Project	IEEE 802.16 Broadband Wireless Access Working Group < http://ieee802.org/16 >	
Title	Proposed changes to clause 15.3	
Date Submitted	2007-09-07	
Source(s)	Mariana Goldhamer Alvarion Ltd. 21A, HaBarzel St, 69710, Tel Aviv, Israel	Voice: +972544225548 E-mail: mariana.goldhamer@alvarion.com
Re:	Task Group Review	
Abstract	Summary of the Ad-Hoc activity	
Purpose	Approval	
Notice	<i>This document does not represent the agreed views of the IEEE 802.16 Working Group or any of its subgroups. It represents only the views of the participants listed in the "Source(s)" field above. It is offered as a basis for discussion. It is not binding on the contributor(s), who reserve(s) the right to add, amend or withdraw material contained herein.</i>	
Release	The contributor grants a free, irrevocable license to the IEEE to incorporate material contained in this contribution, and any modifications thereof, in the creation of an IEEE Standards publication; to copyright in the IEEE's name any IEEE Standards publication even though it may include portions of this contribution; and at the IEEE's sole discretion to permit others to reproduce in whole or in part the resulting IEEE Standards publicat

Figure h48—Candidate Channel Determination Process

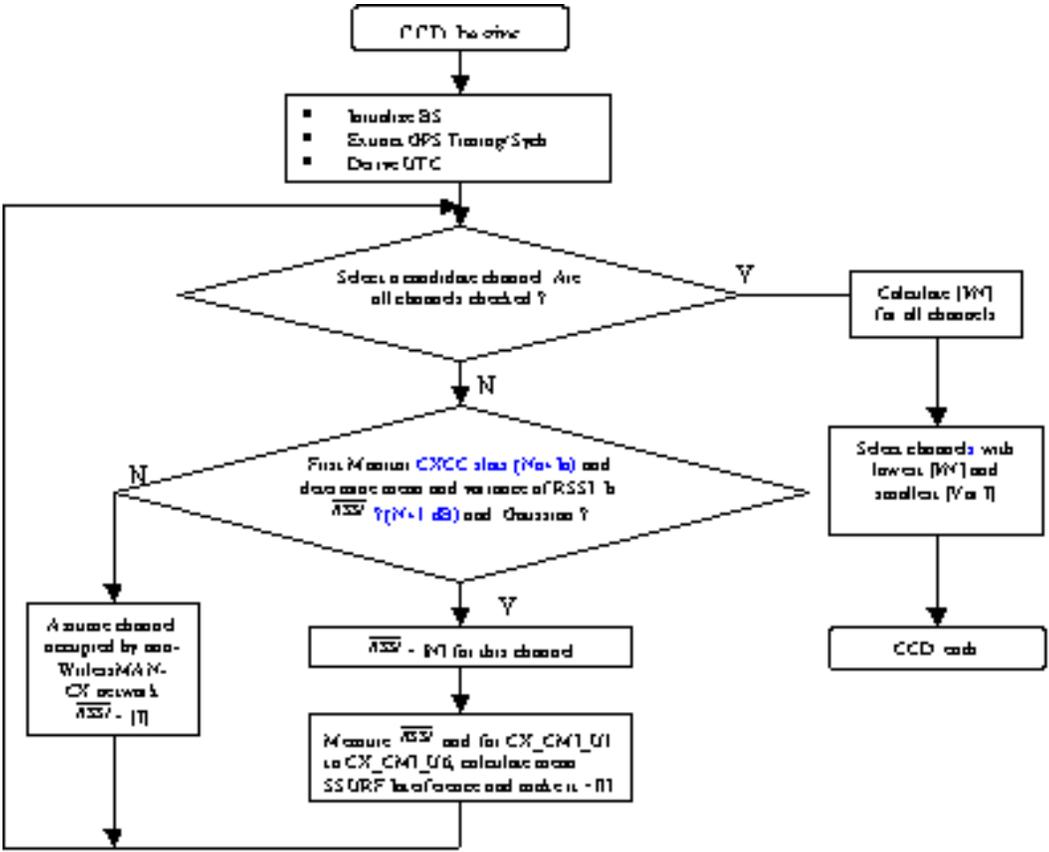
The channels are then ranked, with the channel having the lowest I/N and smallest [Var I] measurements over a maximum number of Master sub-frames to be likely selected for IBS entry into a Coexistence Community. This process is undertaken for each channel that is specified for the band of operation for the WirelessMAN-CX system and in essence identifies "white space" spectrum. Additionally, the passive PSD monitoring process described in section **Error! Reference source not found. Error! Reference source not found.** can be considered as a parallel process to the CCD, and can be used as another method of ascertaining spectrum occupancy. *Candidate Channel Determination Process* (needs changes) shows the CCD process.
